FOR THE MEETING OF: April 15, 2021
AGENDA ITEM: 5.a

TO: Historic Landmarks Commission

CASE NO.: Historic Design Review Case No. HIS21-02

APPLICATION SUMMARY: A proposal to construct a new two story house.

**RED HOUSE
GREEN DESIGNS**

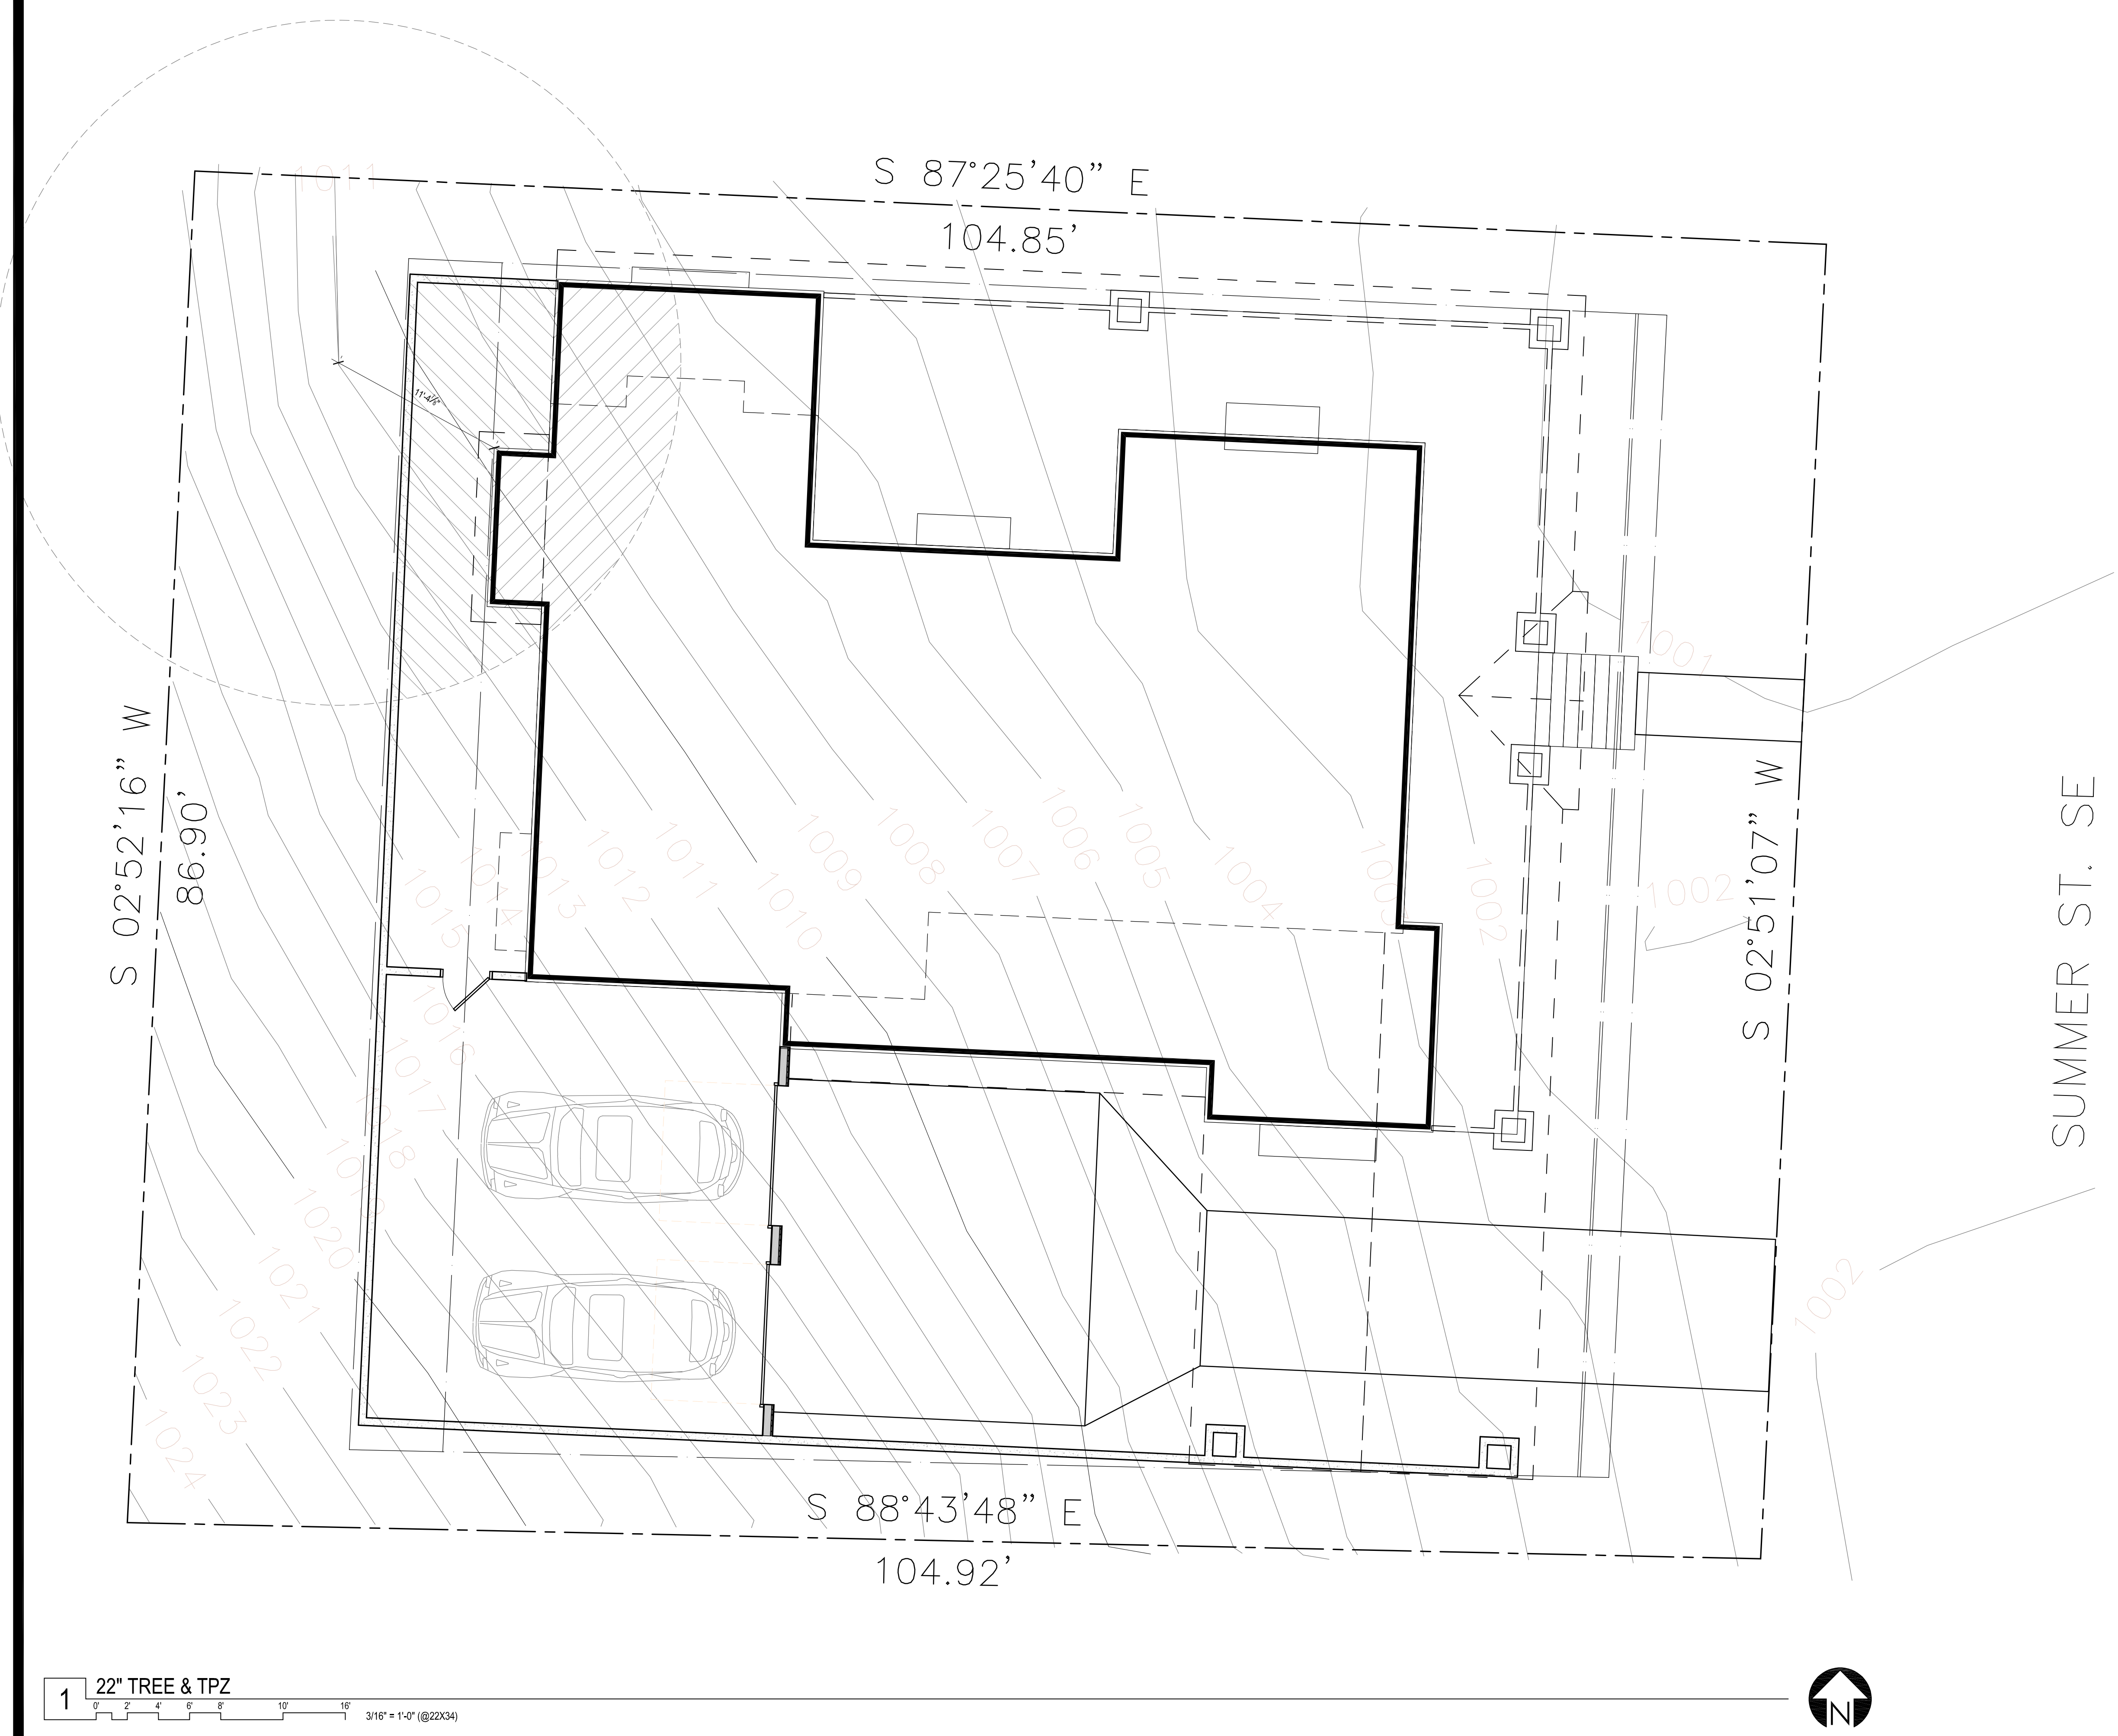
Finding: The applicant has made a concerted effort to ensure that the proposed house is designed to fit on this steeply sloped lot in a way that allows it to fit within the existing neighborhood. There are two oak trees proposed for retention located on the eastern portion of the site abutting Summer Street. The applicant is proposing

to install the driveway within the dripline of these trees. The grade of this driveway will be two feet above the existing grade, in order to meet the existing grade at Summer Street SE, therefore no additional excavation will be required to install the driveway, minimizing the adverse effect to these trees. However, the installation of the porch foundation on the eastern end of the house is also within the dripline of these trees and has the potential to impact the long-term health of these trees. In order to better meet this criterion and ensure that these oak trees have a better chance of survival, staff recommends that the HLC adopt the following Condition of Approval:

Condition 1: In order to reduce the potential adverse effect of the construction on the existing oak trees proposed for retention on the eastern portion property, the applicant shall utilize a pier style foundation under the eastern porch instead of a traditional foundation wall or slab so the building pressure is limited to these pier locations.
